FORT BEND GRAND PARKWAY TOLL ROAD AUTHORITY
FORT BEND GRAND PARKWAY TOLL ROAD
CONSTRUCTION CONTRACT CHANGE ORDER NUMBER : 03
SH 99: At W. Airport
PROJECT NO. 126-1002

- 1) **CONTRACTOR:** Main Lane Industries, LTD
- 2) **CHANGE ORDER WORK STATION LIMITS:**
 Entire Project
- 3) **DESCRIPTION OF CHANGE:**
 1. Asphalt milling for mainlanes at Oyster Creek.
 2. Add standard for rolling closure for construction of overhead sign. - RFI-010 (No cost difference)
 3. Revise north side u-turn alignment and width, and move curb inlet to avoid electrical ground box - RFI-003 (No cost difference)
- 4) **NEW OR REVISED PLAN SHEET(S) / SKETCHES ARE ATTACHED AND NUMBERED:**
 New - Sheet 82A
 Revised plan sheets - 14, 121, 168 and 171.

FORT BEND GRAND PARKWAY TOLL ROAD AUTHORITY
FORT BEND GRAND PARKWAY TOLL ROAD
CONSTRUCTION CONTRACT CHANGE ORDER NUMBER : 07
SH 99: At W. Airport
PROJECT NO. 126-1002

- 1) **CONTRACTOR:** Main Lane Industries, LTD
- 2) **CHANGE ORDER WORK STATION LIMITS:**
Sta 1057+31 to 1060+40 (SBRMP1)
- 3) **DESCRIPTION OF CHANGE:**
 1. Extend MBGF and replace SET past existing overhead sign column since column is in clear zone due to auxiliary lane addition.
- 4) **NEW OR REVI

DESIGNED	CA	HORIZ SCALE	SHEET 8 OF 12
CHECKED	JB	VERT SCALE	
APPROVED	JB	DATE	7/9/2020
		SHEET NO.	103
CSJ		SECTION

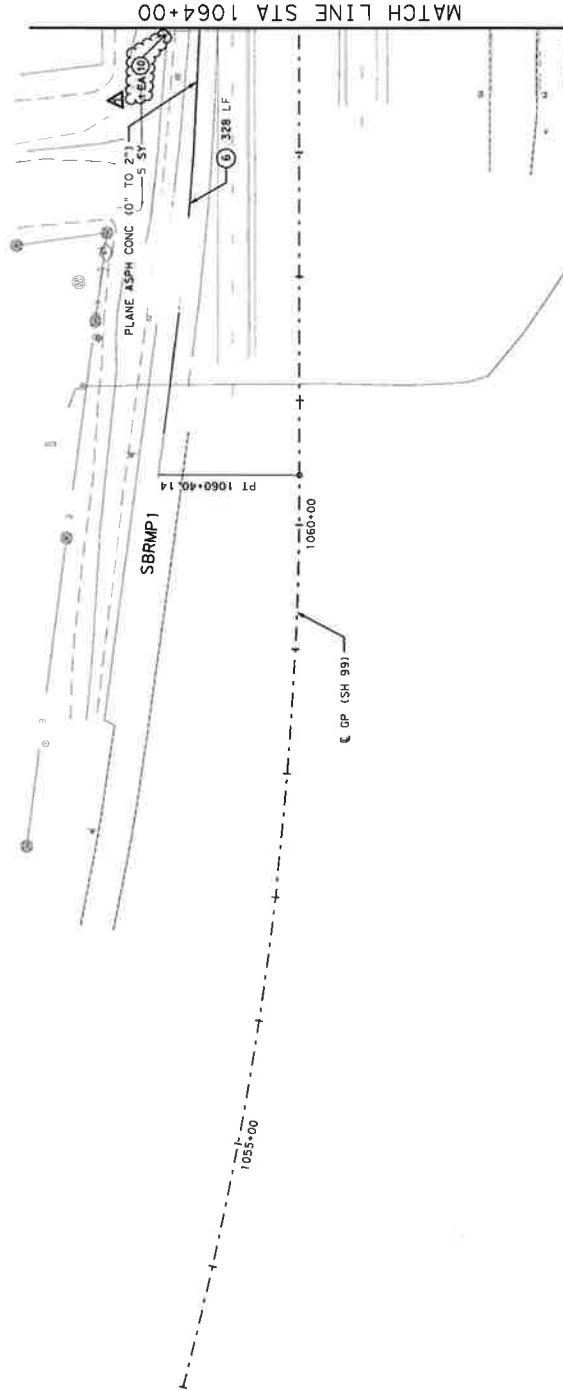
NO.	DATE	REVISION	QAO	APPROVED
1	11/22	REMOVE MBGF

SINGLE GUARDRAIL TERMINAL

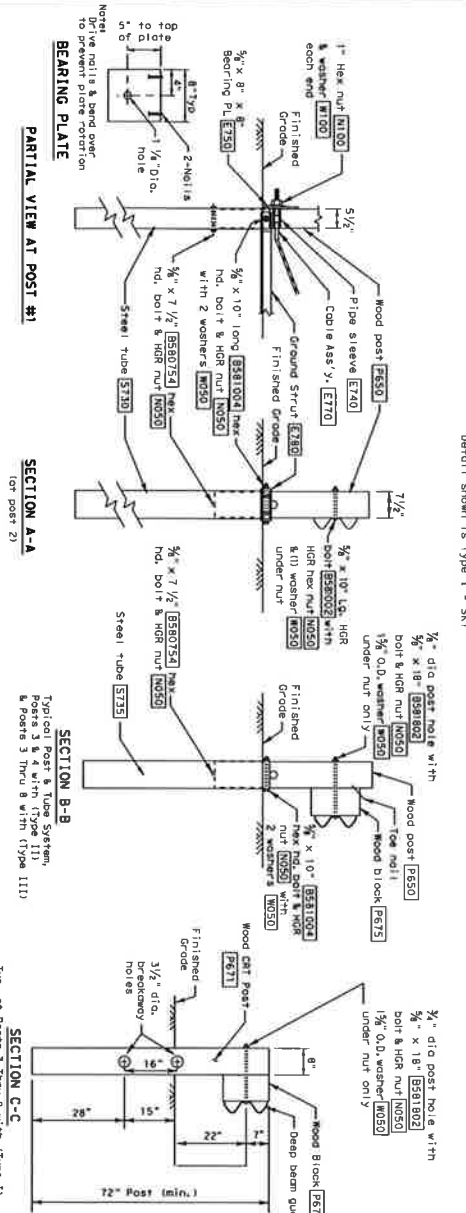
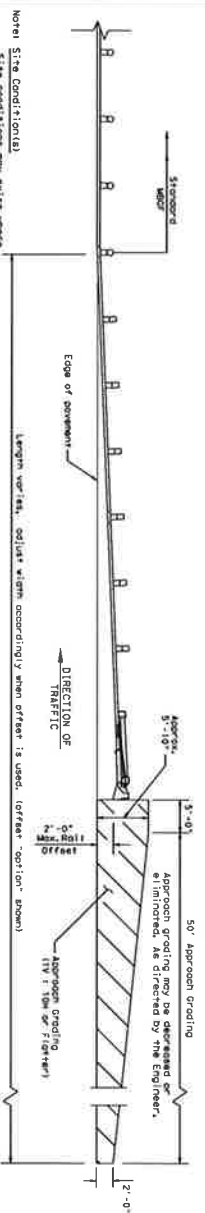
Subject: Added Remove & Install Guardrail End Treatment (TY I)(Old Spec - 28") (1EA)

NOTE: This Quote Includes Furnishing An Old Spec (28") TY I Guardrail End Treatment - MATERIAL IS NOT MASH COMPLIANT
